Access Compliance Report

Public Rights-of-Way

(Curb Ramps)

Intersection ID: 20969	Main Street: OLD_REID_RD	Cross Street: PARK_RD	Location: SE
ADA ID: C339CA9F4741	Ramp Type: PerpDiag	Initial Pass/Fail: Fail	Overall Compliance: No
		Severity Score: 12.5

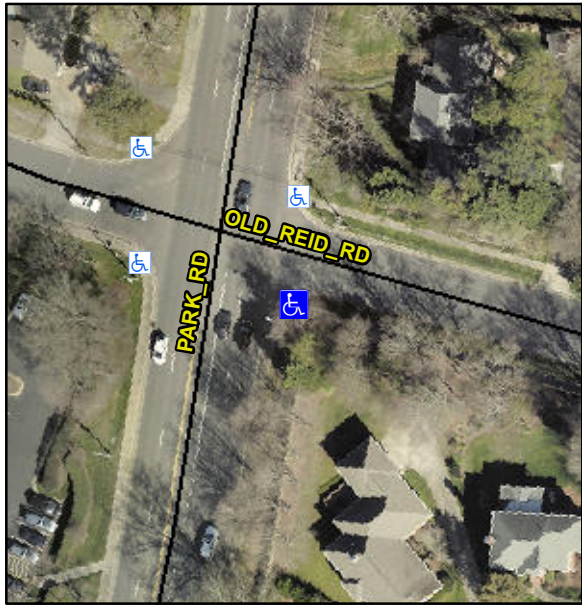
Codes/Mitigation Info/Possible Solution			Field Measurements/Component Compliance					
	Possible Solutions:		Compliance	Description	Data	Compliance	Description	Data
	Remove & Replace Curb Ramp With Two New Directional Ramps or Equivalent.		N/A	Ramp Length (in)	83.0	Yes	Ramp Slope (%)	5.7
			Yes	Ramp Width (in)	48.0	No	Ramp XSlope (%)	5.2
			N/A	Flare Type LT	N/A	N/A	Flare Type RT	N/A
			N/A	Flare Slope LT (%)	N/A	N/A	Flare Slope RT (%)	N/A
			N/A	Flare Traversable LT?	N/A	N/A	Flare Traversable RT?	N/A
			N/A	Landing Length (in)	N/A	N/A	DWS Provided?	N/A
			N/A	Landing Width (in)	N/A	N/A	DWS Contrast?	N/A
			N/A	Landing Slope (%)	N/A	N/A	DWS Length (in)	N/A
			N/A	Landing X Slope (%)	N/A	N/A	DWS Full Width?	N/A
Surveyor Notes:		N/A	N/A	Landing Curb? (Y/N)	N/A	N/A	DWS Offset (in)	N/A
			N/A	Shared Landing?	N/A			
PROW/ADA:		Not Found, R304.5.3	N/A	Gutter Ponding?	N/A	N/A	Gutter Slope (%)	N/A
			N/A	Gutter Lip Ht (in)	0.5	N/A	Gutter X Slope (%)	N/A

N/A	Painted X Walk1?	No	N/A	Painted X Walk2?	No
				X Walk 1 Direction	To NE		X Walk 2 Direction	To NW
			N/A	X Walk 1 Width (in)	N/A	N/A	X Walk 2 Width (in)	N/A
				X Walk 1 Slope (%)	3.2		X Walk 2 Slope (%)	1.5
				X Walk 1 X Slope (%)	2.4		X Walk 2 X Slope (%)	0.5
			N/A	Ramp inside XWalk1?	N/A	N/A	Ramp inside XWalk2?	N/A
				Road Slope (%)	0.9	N/A	Clear Space?	N/A
				Road X Slope (%)	1.9	N/A	Clear Space to XWalk (in)	N/A
			N/A	Any Obstructions?	N/A	N/A	Storm Grate/Utility Hazard?	N/A
				Obstruction Type			Storm Grate/Utility Type	
					N/A			N/A
						Yes	Surface Condition? (G/P)	Good
Street 1 Name		OLD REID RD						
Stop Condition-Street 2		StopSign						
Street 2 Name		PARK RD						
Stop Condition-Street 1		None						
Total Cost:		\$ 3200.00
